**MIXED USE AND SENIORS LIVING
DEVELOPMENT**
5 Skyline Place Frenchs Forest NSW 2086
SP 49558

SCALE:	AS SHOWN	DRAWING DA101 ISSUE
SUBSET:	SITE PLAN	
DRAWN BY:	SUM/WH/SP

SECTION 4.55(8)

LOWER BASEMENT CARPARK

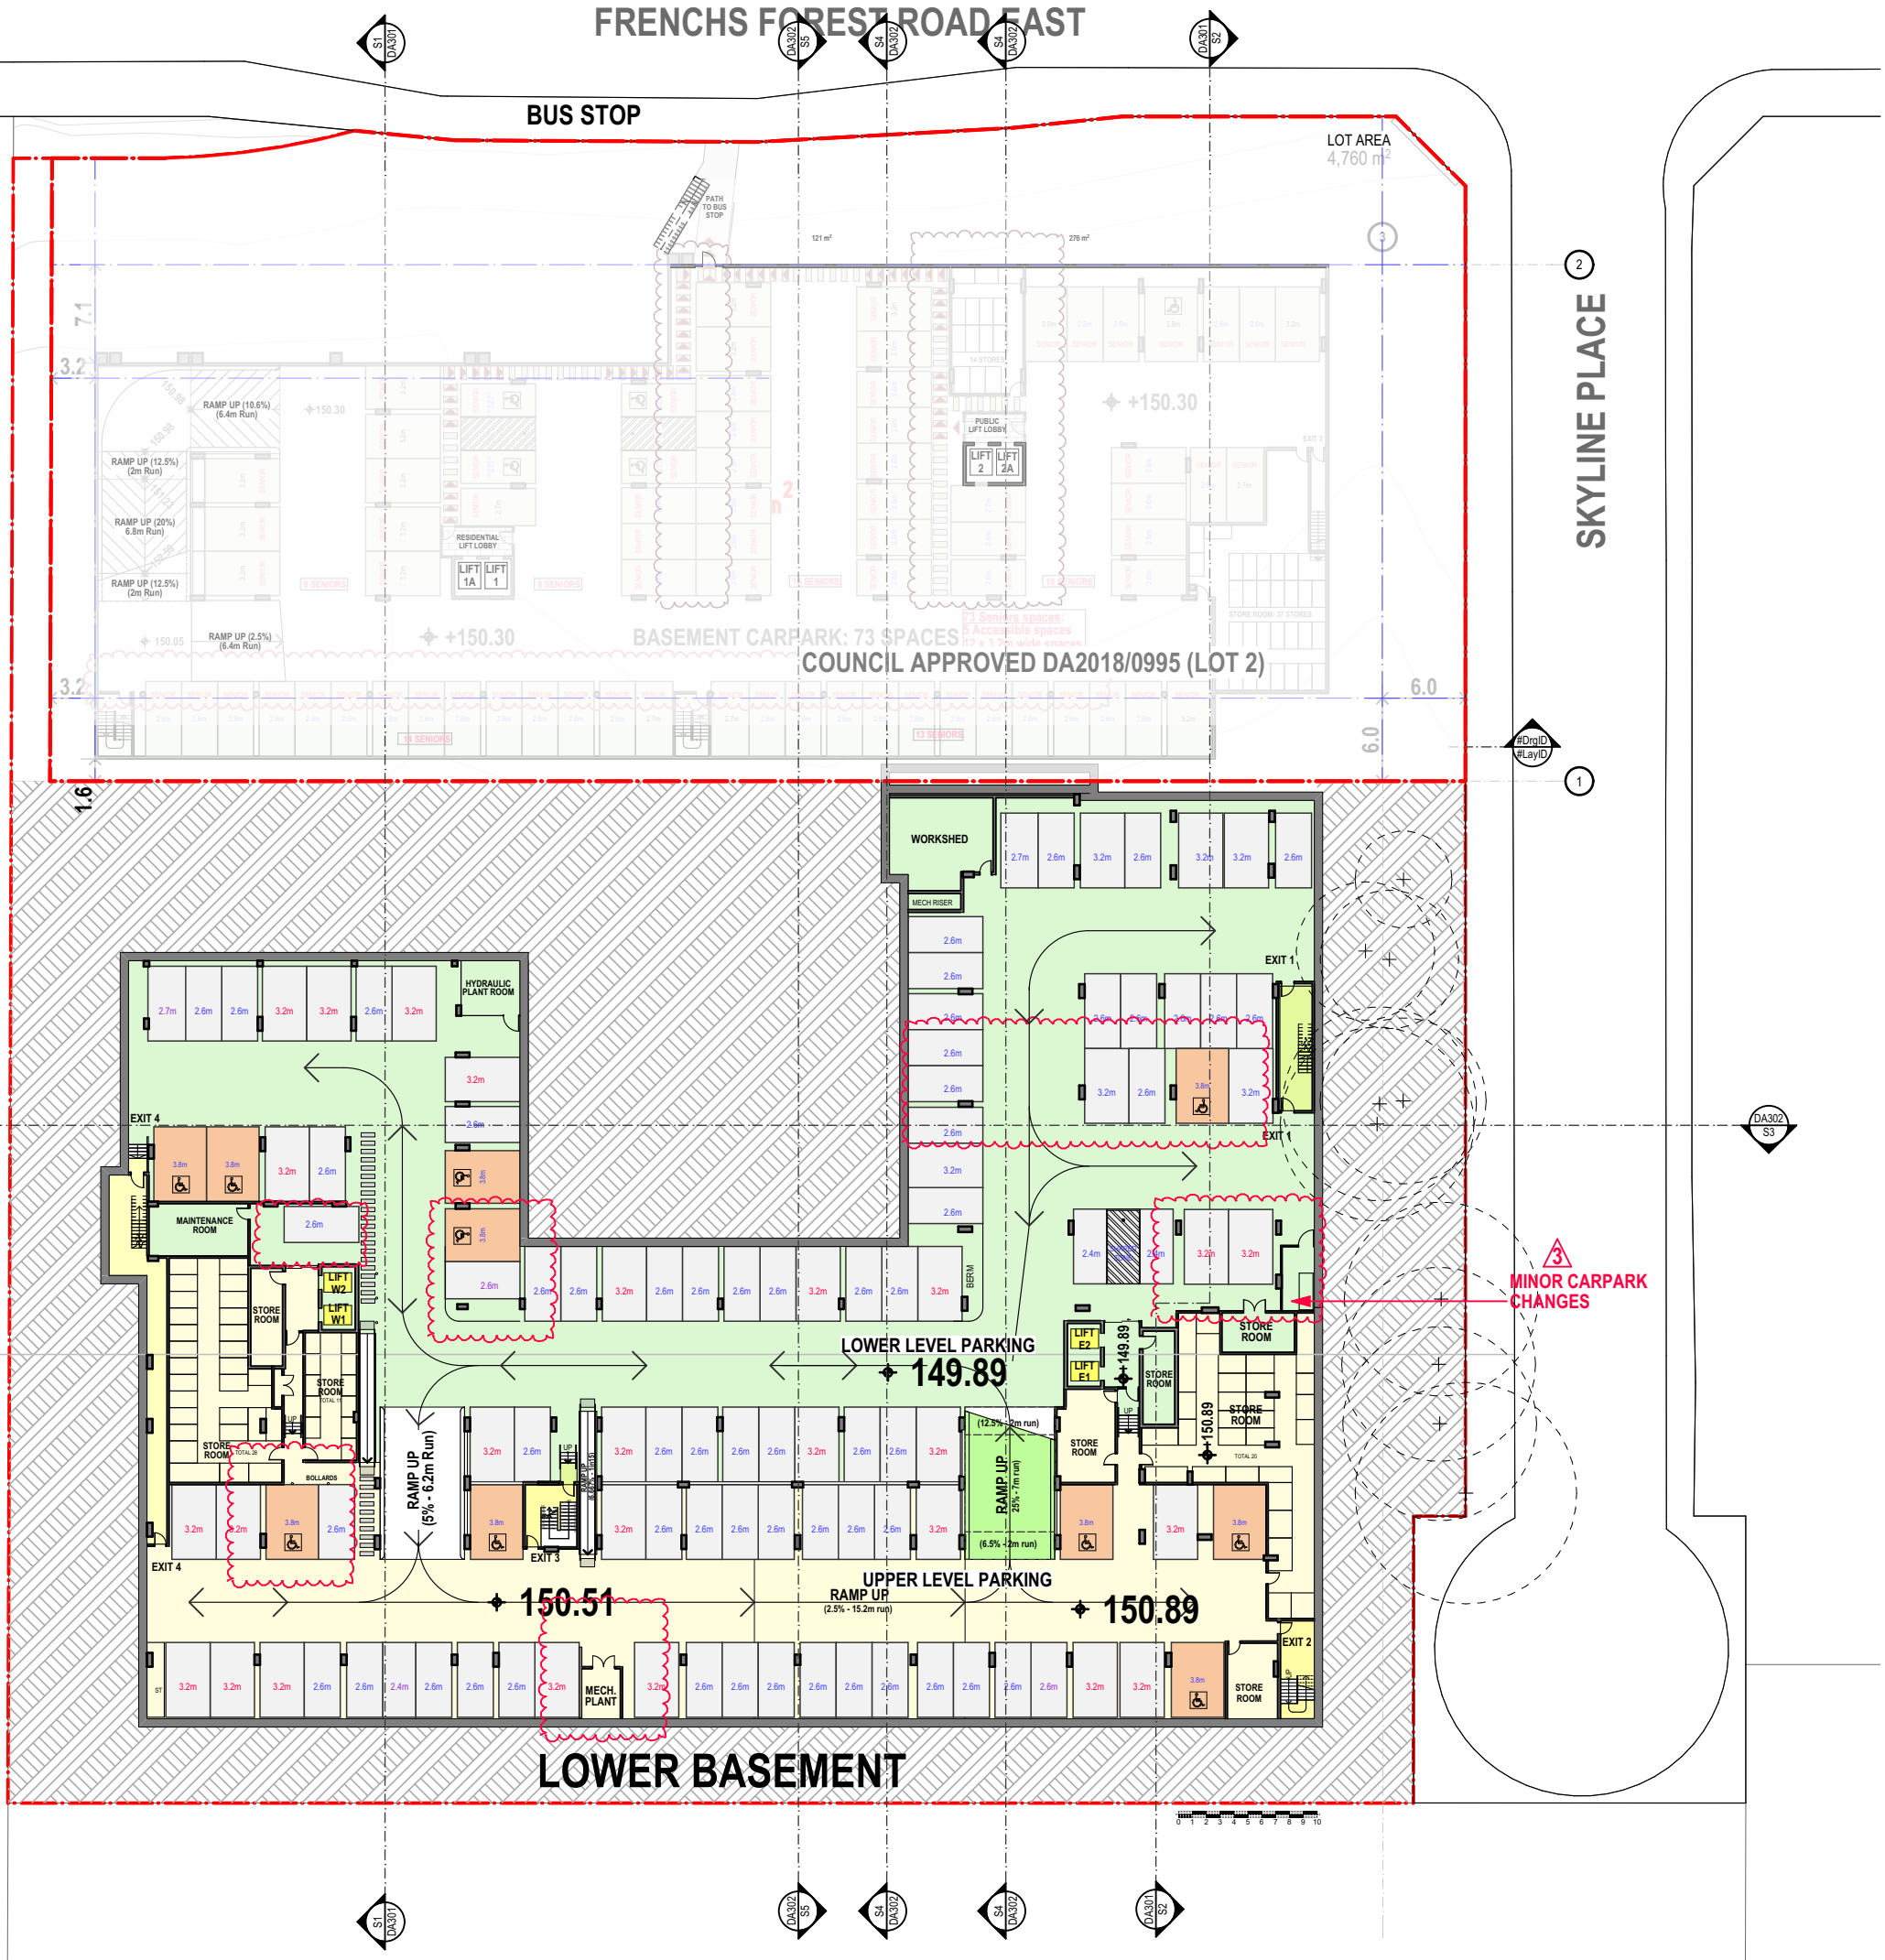
3 MINOR CARPARK CHANGES

GROUND FLOOR PLAN

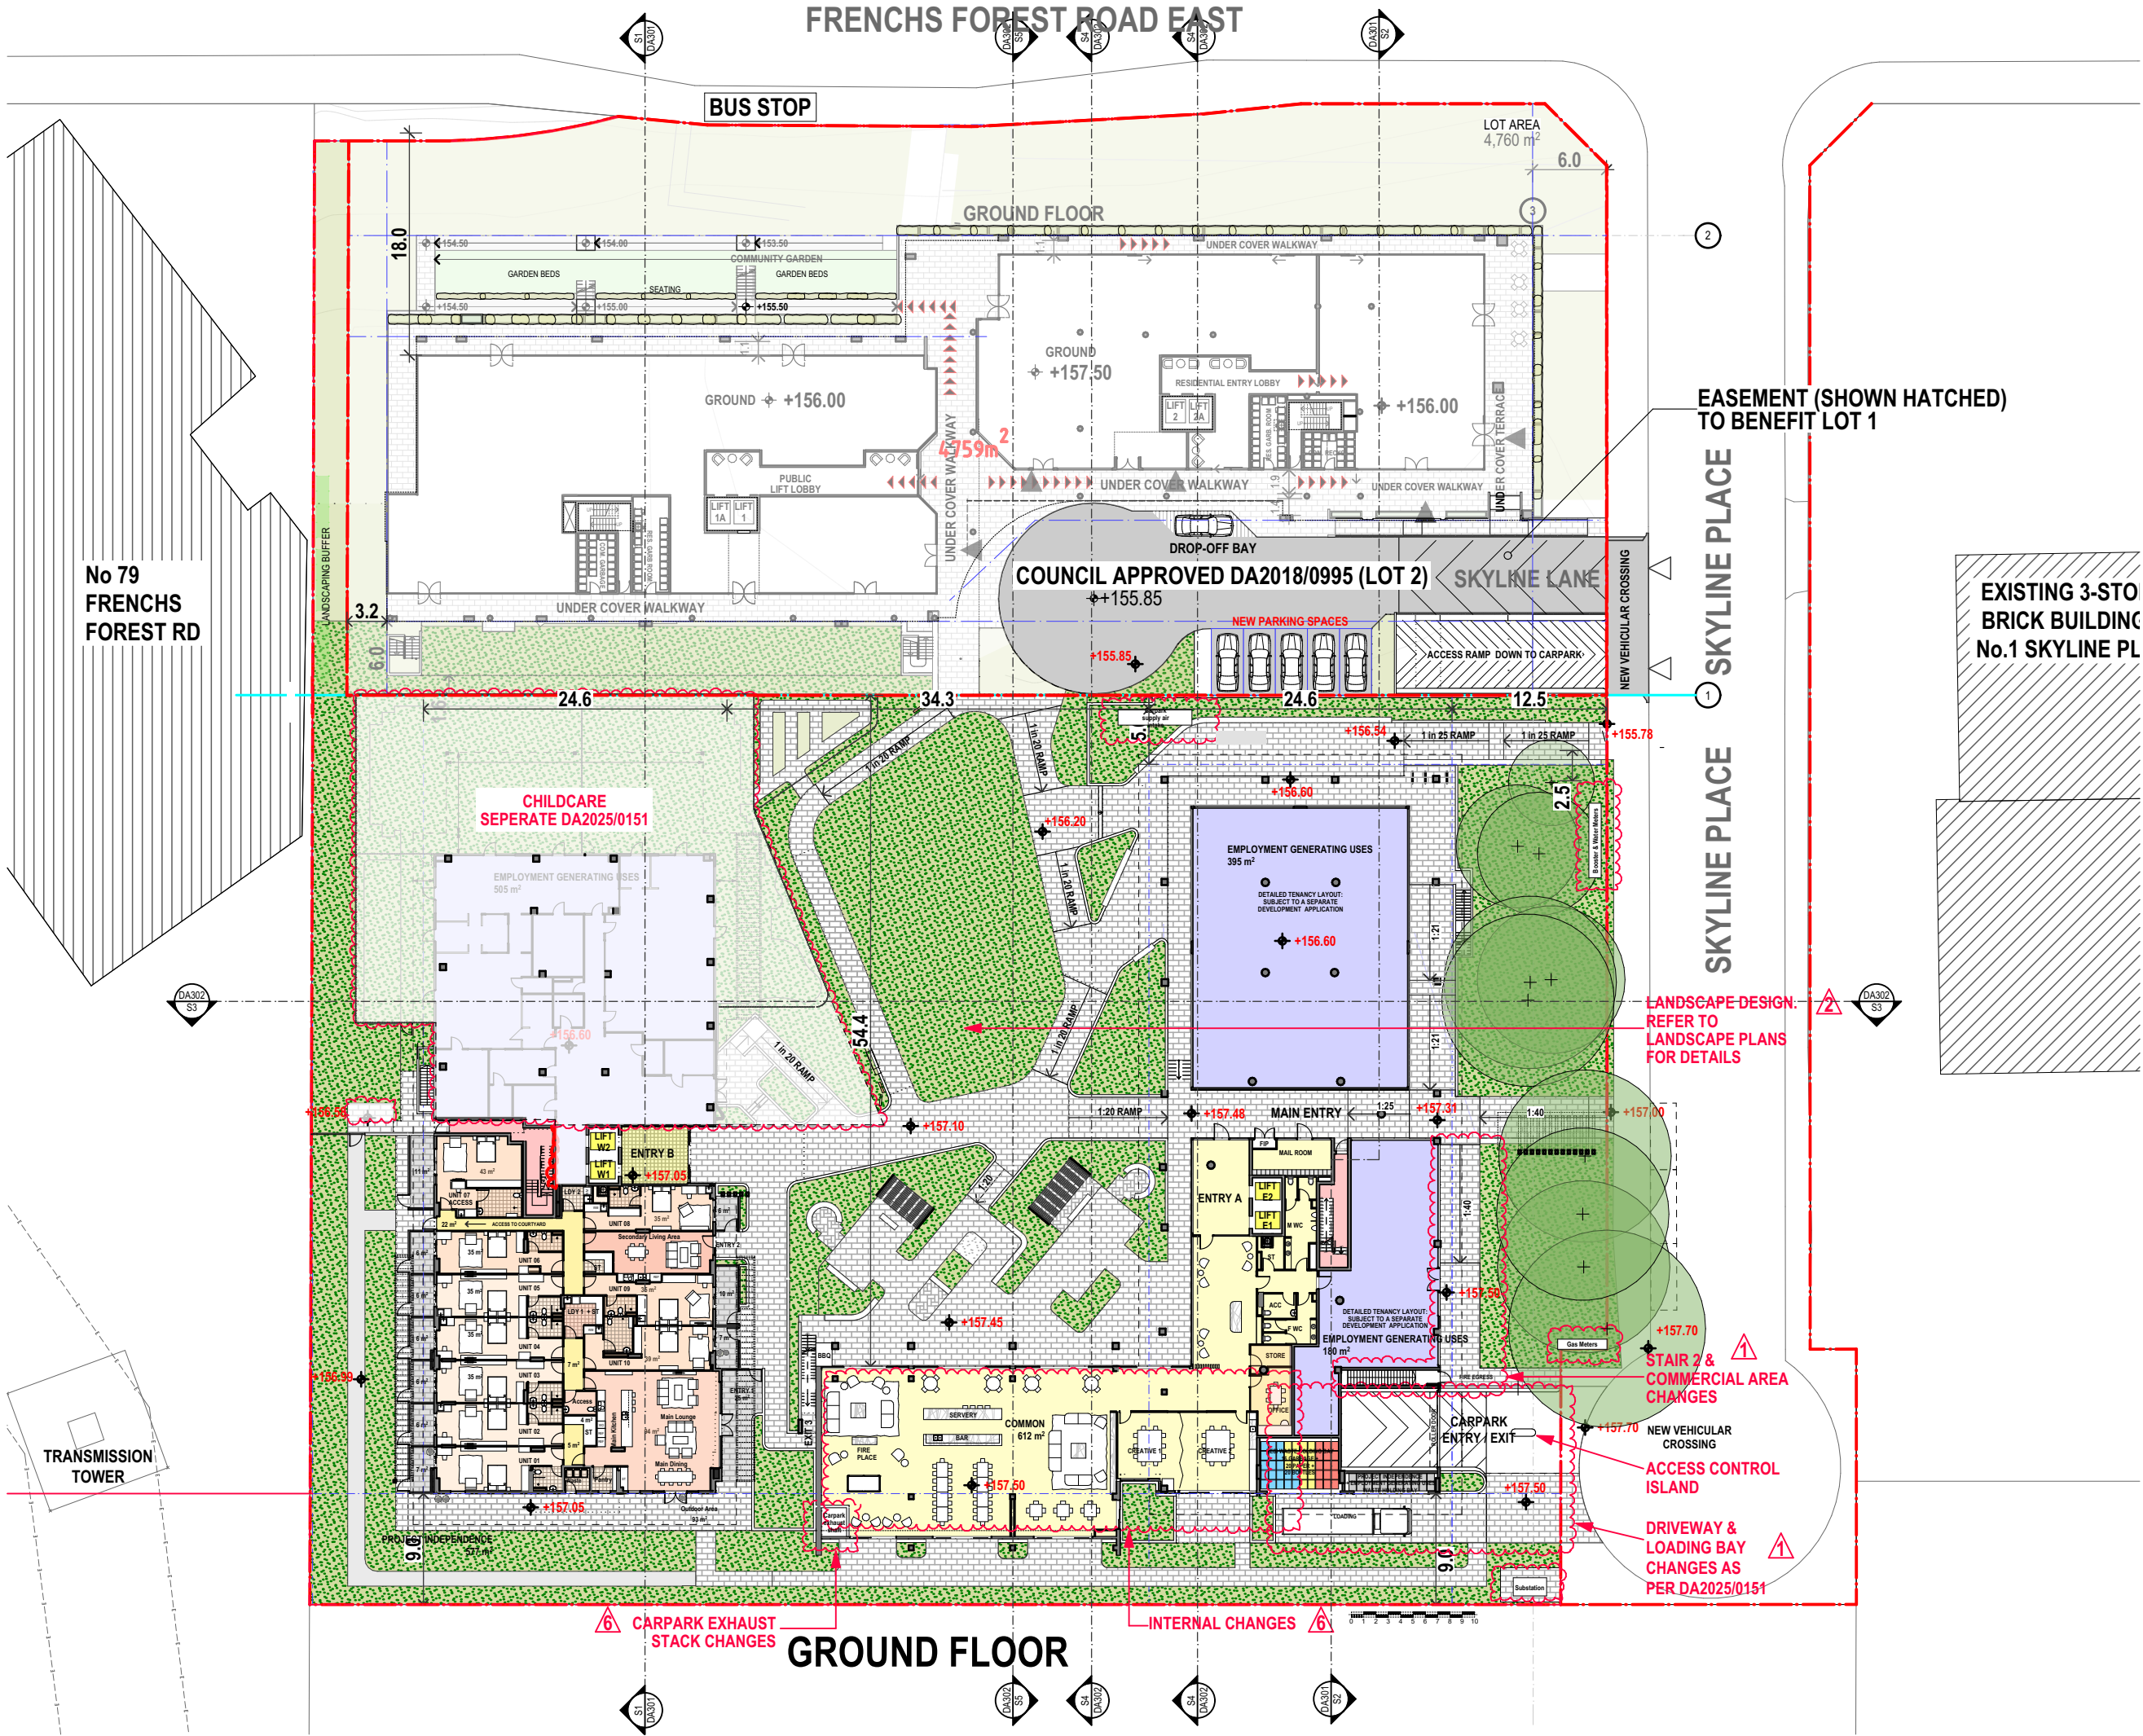
STAIR 2 & COMMERCIAL AREA CHANGES

DRIVEWAY & LOADING BAY CHANGES AS PER DA2025/0151

CARPARK EXHAUST STACK CHANGES

INTERNAL CHANGES

LEVEL 2 FLOOR PLAN

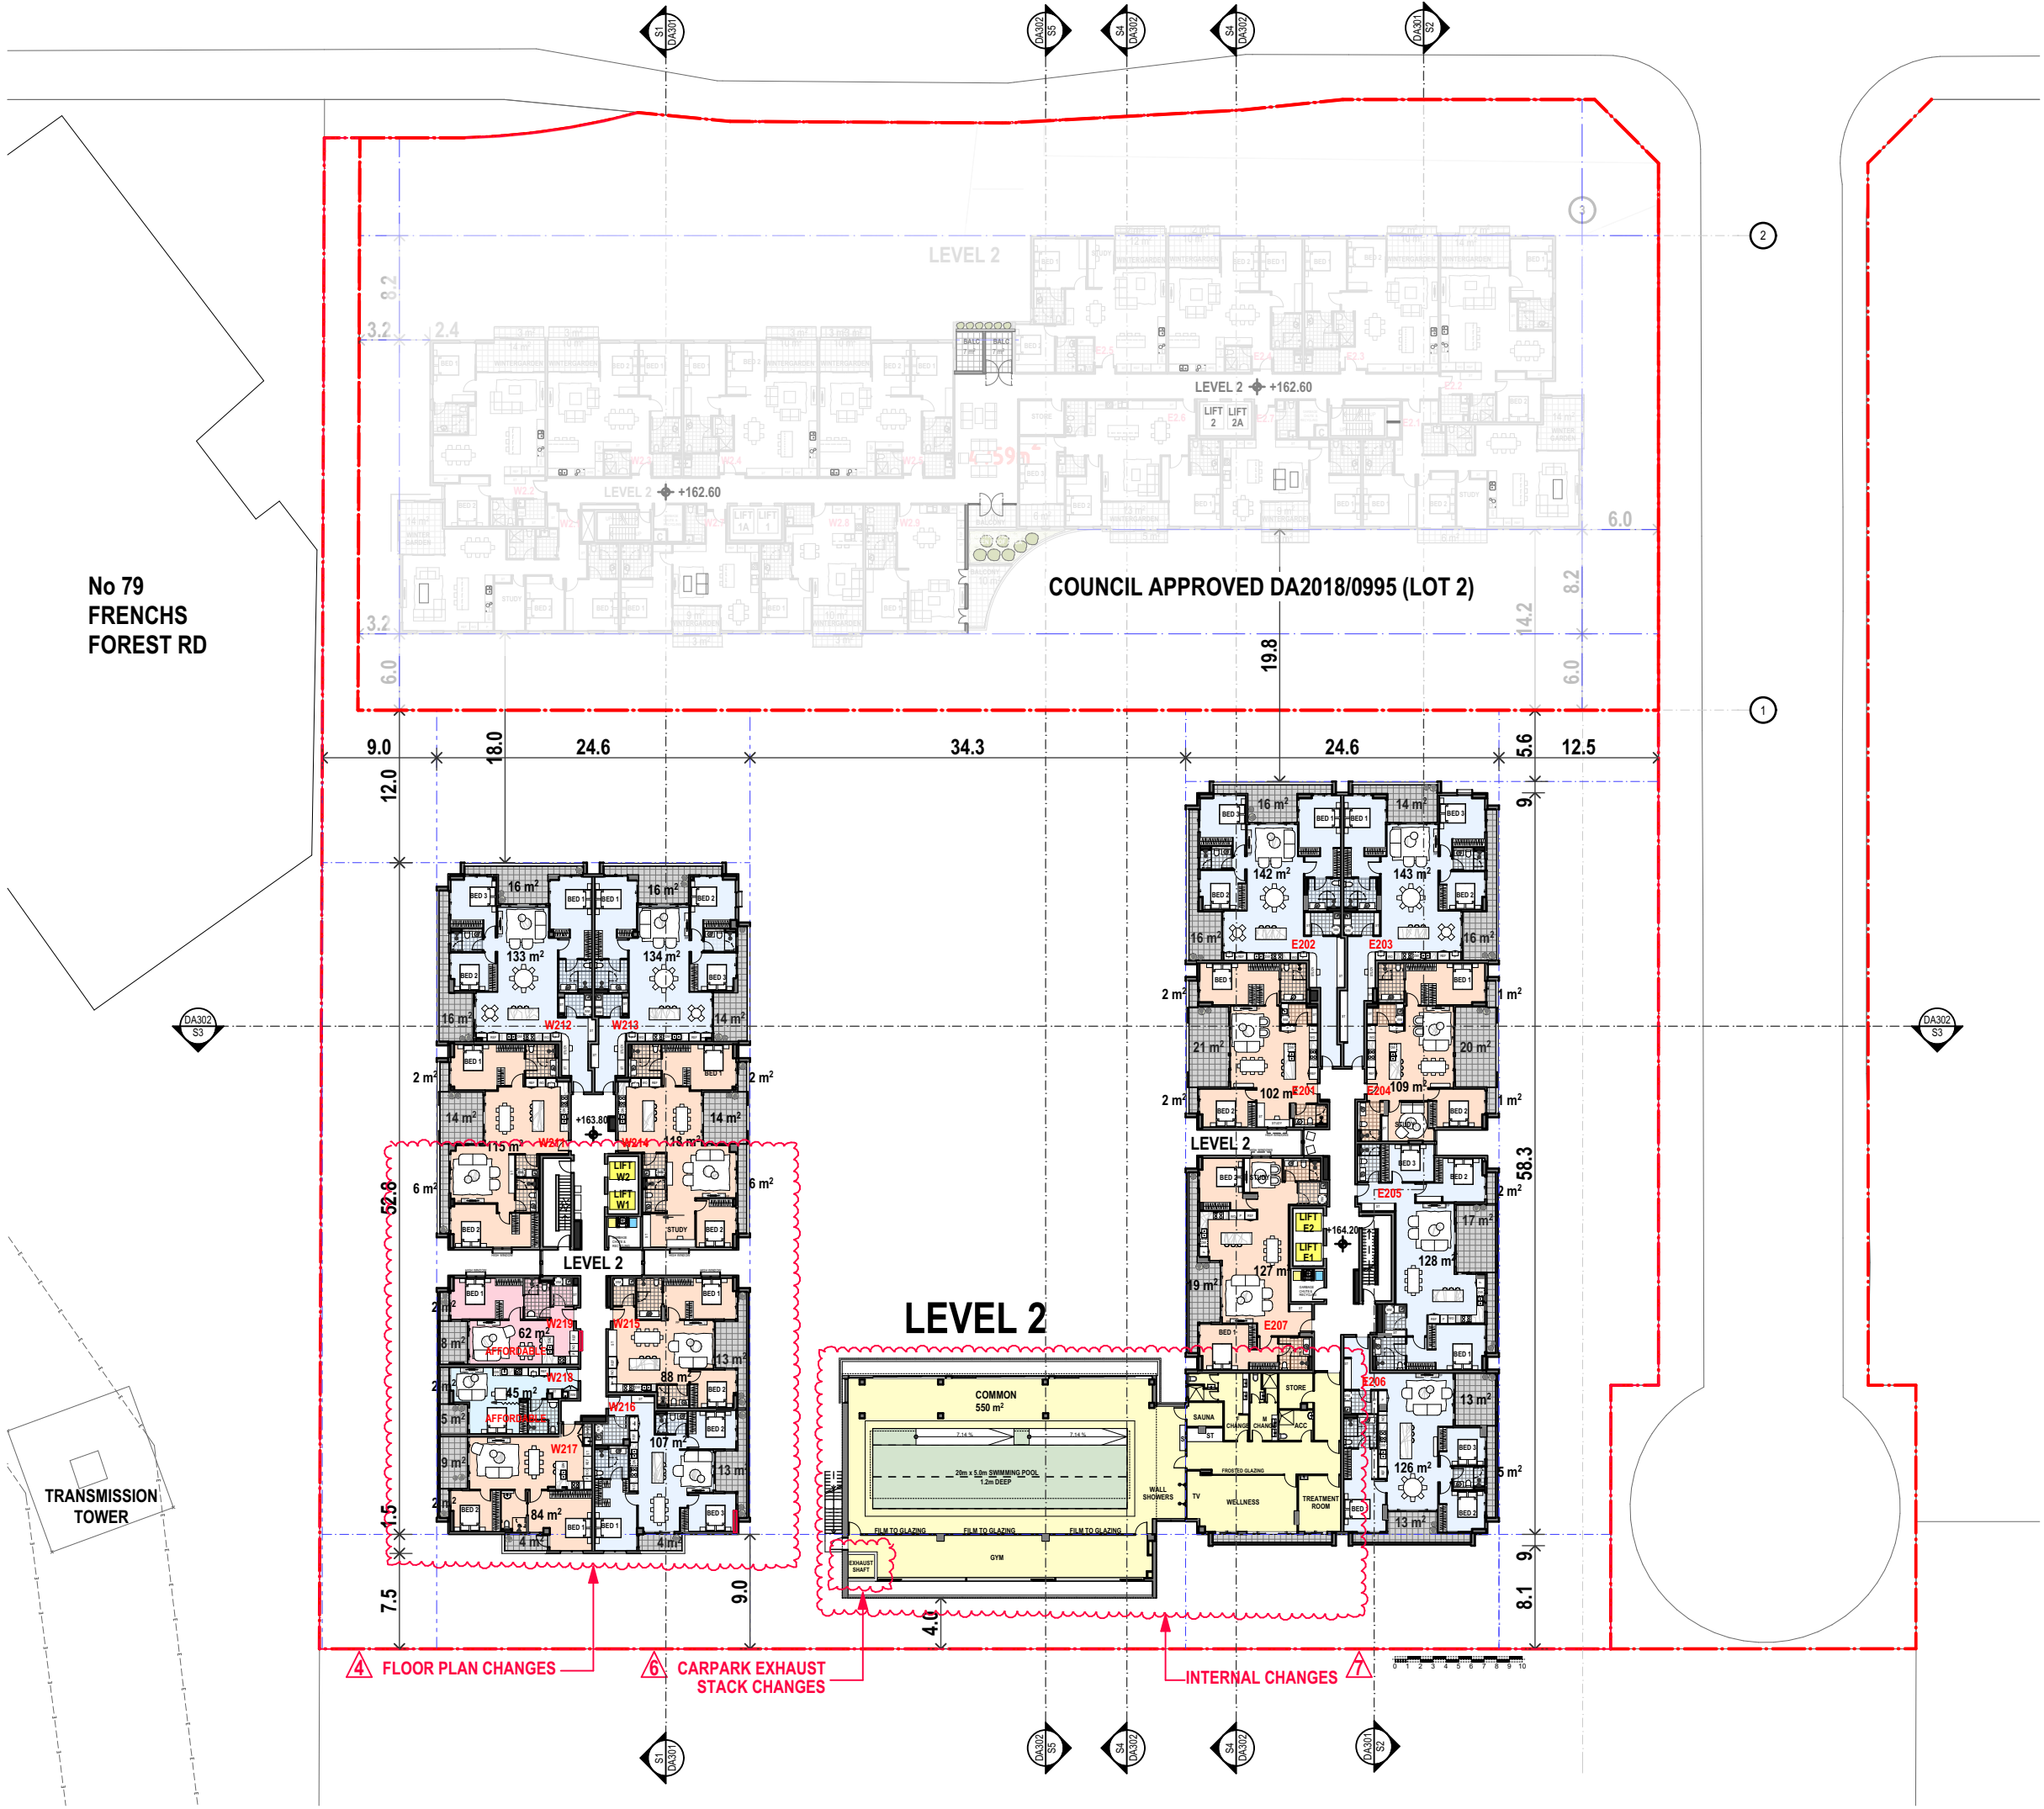
4 FLOOR PLAN CHANGES

6 CARPARK EXHAUST
STACK CHANGES

INTERNAL CHANGES
